**Marion County
Board of County Commissioners**

**PLANNING & ZONING SECTION
STAFF REPORT**

Dates	<u>Continued from</u> BCC: 05/21/2024	BCC: 09/17/2024
Case Number	230109ZP – REVISED PLAN	
CDP-AR	29265	
Type of Case – Rezoning	From Single Family Dwelling (R-1) & Planned Unit Development (PUD, expired) To <i>PUD for 111 single family detached residential units (north) and 100 single family detached residential units (south); totaling 211 dwelling units.</i> (Originally, 304 multiple family dwellings (north), and 58 single family dwellings (south) totaling 362 units.)	
Owner	Dimino Holdings Associates, LLC, as Trustee for BaseDev Land Trust, dated January 31, 2022	
Applicant/Agent(s)	Red Jacket Development Group, LLC; c/o Clay Frankel	
Street Address / Site Location	No address	
Parcel Number	37515-004-00 – ±25.75 Acres (4.31 DU/AC proposed) 37515-004-02 - ±26.40 Acres (3.78 DU/AC proposed) Total - ±52.15 Acres (4.05 DU/AC proposed)	
Property Size	±52.15 acres	
Future Land Use	High Residential (HR; 4-8 DU/AC; 208 – 417 DU)

Figure 6
Existing Adjoining Fountains at Golf Park Subdivision
with Property Acreage

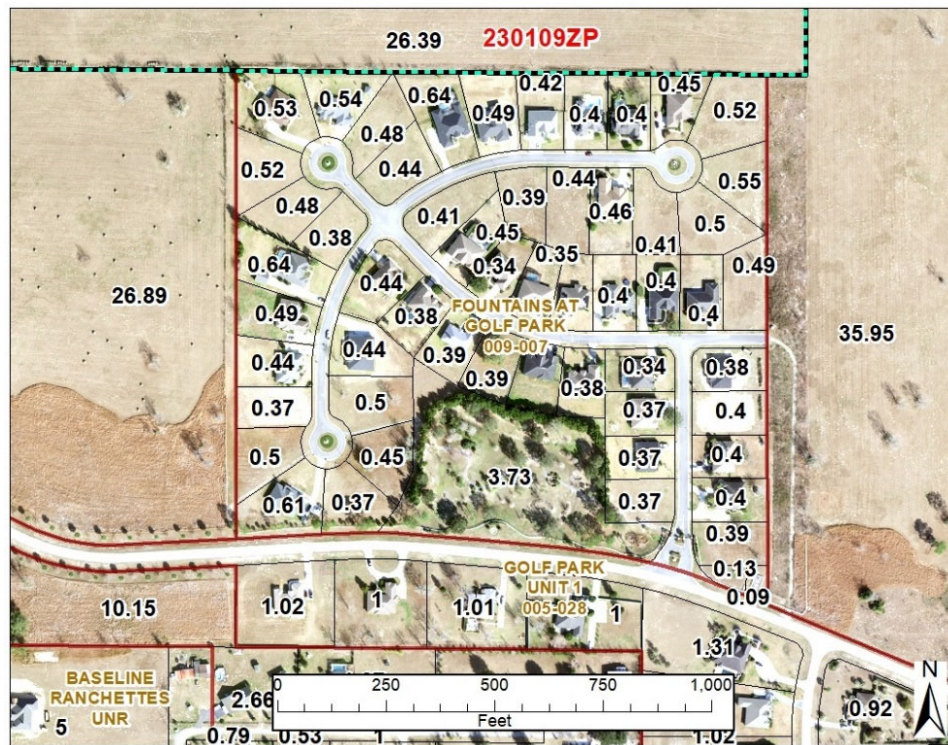
Deeper and wider single family detached residential lots are proposed on the southern PUD portion that adjoins the Fountains. Lots within the Fountains are typically $\pm 100'$ wide and range from 0.34 to 0.65 acres in size as illustrated in Figure 6 above. This results in a functional "2 to 1" ratio for homes in the revised PUD "backing up to" the Fountains. However, the revised PUD proposes a Type-C Buffer (minimum 15' wide, two shade trees, three accent/ornamental trees for every 100 lineal feet or fraction thereof along with shrubs & groundcovers, excluding turfgrass, to comprise at least 50 percent of the buffer to form a layered landscape screen with a minimum height of three feet achieved within one year) along the boundary shared with the Fountains.
